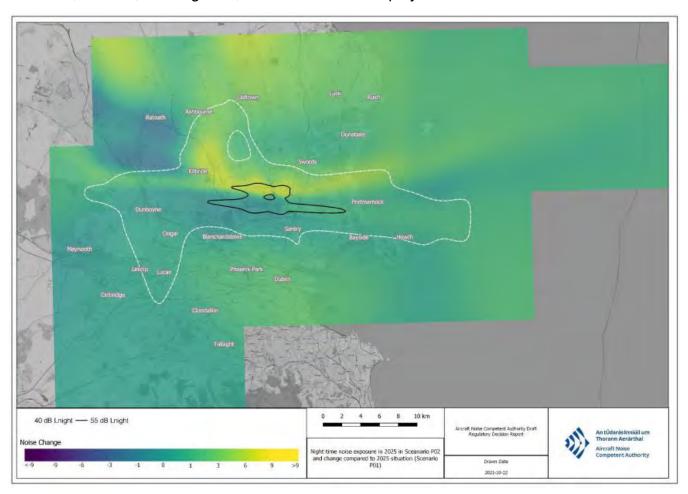
- Scenario P02 does not meet the NAO when taking population growth into account.
- Scenario P11 has just an increase of 2 people contained in the >55dB Lnight contour compared with 2019. This is well within the margins of error of the forecasts and should not be excluded from further analysis.
- ANCA used population with growth to dismiss scenario P11 yet attempted to ignore population with growth to justify the inclusion of P02.
- Night noise imposed on new populations from the North Runway for only a gain of 2 extra flights between 06:00-08:00 and 4 between 22:00-24:00, as outlined in the daa's forecasts.
- Scenario P11 shows less night-time impact than P02 and has lower numbers of HSD and HA.
- Including P02 and excluding P11 is not a Balanced Approach!

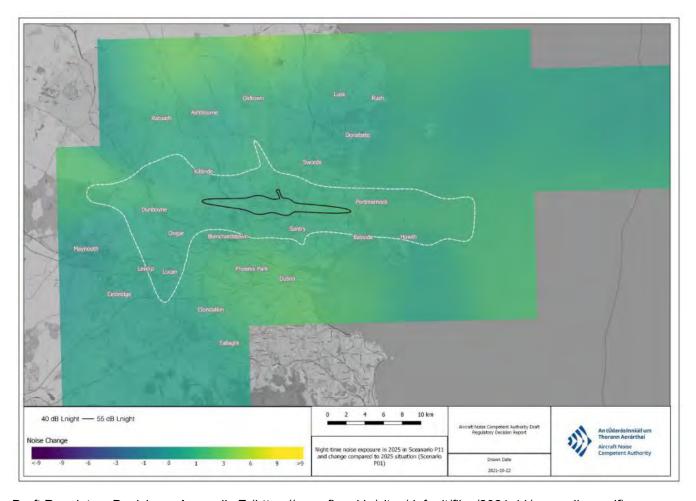
Comparing the difference maps between scenarios 02 and 11 with scenario 01 (Permitted) one can see that scenario P11 causes no significant changes in noise exposure and a scenario that that ANCA should favour.

Scenario P02 introduces whole new populations to night-time noise for the first time, primarily in Malahide, Swords, St Margarets, The Ward and Coolquay

Figure 7.14: Population exposed to levels above the NAO priorities under different runway use and restriction scenarios with and without potential population growth

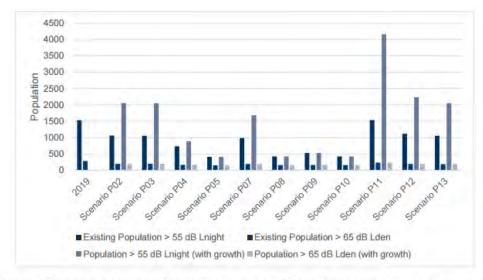
The Draft Regulatory Decision document focuses on >55dB Lnight and HSD only. In Fig 7.14 it shows the >55dB Lnight and >65dB Lden figures for 2025 for all the scenarios vs 2019.

Scenario P11 exceeds 2019 when population growth is taken into account. Population growth is made up of future occupied, future consented planning and future zonings.

In Fig 7.14 ANCA do not show the population growth for 2019, just the actual figure at that time which was 1533.

The top row in the table above is a comparison of >55dB Lnight exposure without population growth. Scenario P11 is 1535 which is just 2 people above the 2019 level and well within the tolerance of error with forecasts. Being above the 2019 figure by just 2 people should not be used as a mechanism to dismiss scenario P11.

Figure 7.15: Population exposed to levels above the NAO night time priority of 55 dB L<sub>night</sub> under different runway use and restriction scenarios with potential population growth over the period 2025 to 2040

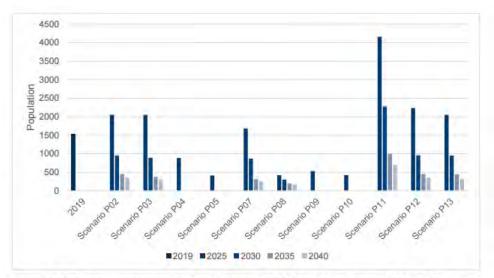
ANCA then compares future years to highlight the scenarios that exceeds >55dB Lnight in 2025/2030/2035/2040 with population growth. P11 exceeds the 2019 figure but so too does P02, the daa's proposal.

P02 fails to meet the NAO when using population growth.

Figure 5.1 – Change in night-time noise exposure of RD Alternatives (v), (vi), (vii) and (viii) (represented by runway use patterns P11, P02, P13 and P04) at designated nature conservation sites in the vicinity of Dublin Airport

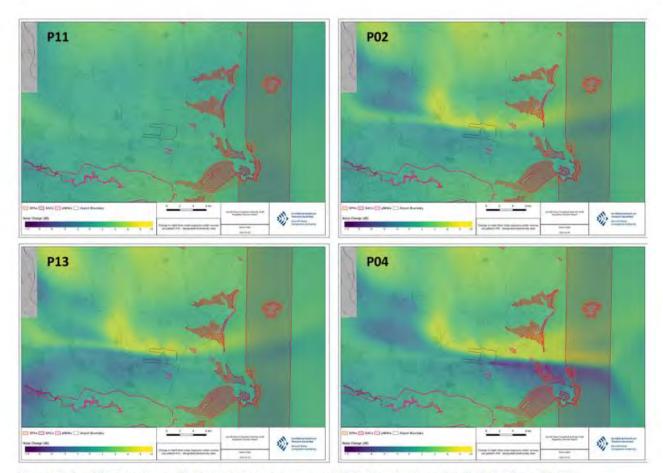
Section 6.62 of the SEA report visually compares scenarios P02 and P11. In section 6.60 it states:

"6.60 In terms of the alternatives to Condition 3(d), Alternative (v) (i.e. runway use pattern P11) is likely to have a negligible effect on protected sites and species, as with aircraft expected to operate as currently (with just the increase in night flights associated with lifting Condition 5) the overall level of noise will increase very slightly everywhere (i.e. for all of the designated sites within the ZoI), as shown in Figure 5.1. In contrast, the changes to operations associated with each of the other runway use patterns result in a much greater level of noise (of up to 9.5 dB) occurring along the descent and take-off routes of the North Runway as night-time flights begin to operate from here, and a potential reduction in noise (of up to 1.5 dB) along the descent and take-off routes of the South Runway as some of these flights are moved to the North Runway. These are also shown in Figure 5.1, with runway use pattern P02 shown for Alternative (vi), and Alternatives (vii) and (viii) represented by runway use patterns P13 and P04 respectively".

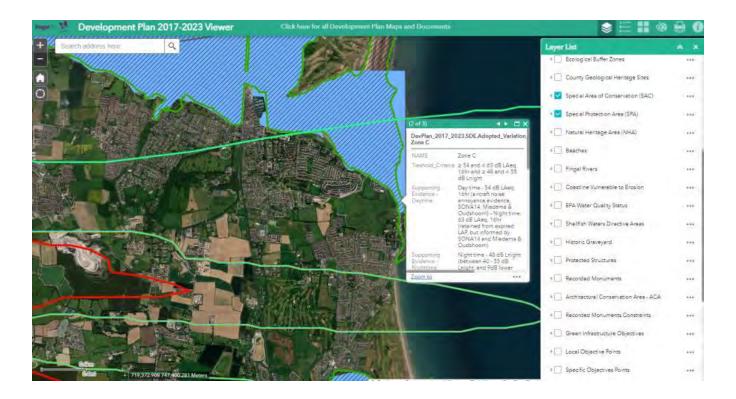
The screening report incorrectly states that the proposals can have no effects on SACs. Malahide SAC will be directly overflown by the plans to operate a divergent route for Easterly departures on the North Runway in mixed-mode operation. This divergent route has no planning permission and was never proposed in the original planning in 2004-2007 under Option 7b.

As can be seen this Easterly departure route on the North Runway has a 15 degree divergnce path and takes a route over Robswall Park in Malahide and over the Malahide SAC.

It is a failure of the screening process to even acknowledge this potential to affect a SAC and as a minimum, appropriate assessment is warranted.

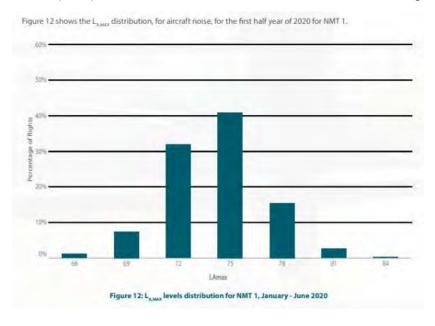
The report provides the LAmax distribution for NMT1 in figure 12:

Figure 12 shows that approximately 58% of aircraft movements detected at NMT1 had a LAmax value > 75 dB. Approximately 18% had a LAmax value > 78 dB and 2.5% > 81 dB.

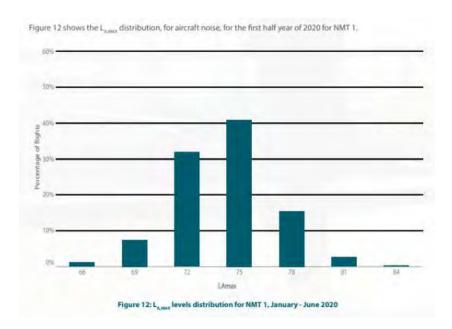
The report provides the LAmax distribution for NMT1 in figure 12:

Figure 12 shows that approximately 58% of aircraft movements detected at NMT1 had a LAmax value > 75 dB. Approximately 18% had a LAmax value > 78 dB and 2.5% > 81 dB.
